Department of Transportation

MEMORANDUM

SUBJECT: ZC Case No. 19-19 – 3301 23rd Street SE (Terrace Manor)

Figure 1 | Site Plan

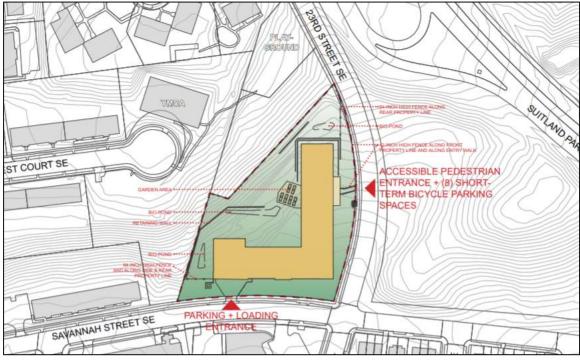
- DDOT does not object to the location and design of the loading berth on private property as shown, but the portions of the driveway within the DDOT right-of-way and building restriction area will need to be further refined during public space permitting to minimize pavement. This may result in back-in loading;

The Applicant proposes to close the existing curb cut on 23rd Street SE that leads to the existing surface parking lot, but proposes a new curb cut on Savannah Street SE that leads to the parking garage. Figure 1 below shows the site layout of the proposed project.

The building is designed so that all loading activities, including delivery and moving trucks, take place in the loading entrance of parking garage located on Savannah Street SE, as shown in Figure 1 above. Trash trucks will enter via back-in maneuvers with a member of the collection team serving as a flagger to assist with maneuvers and alert traffic during collection. While back-in deliveries are typically not
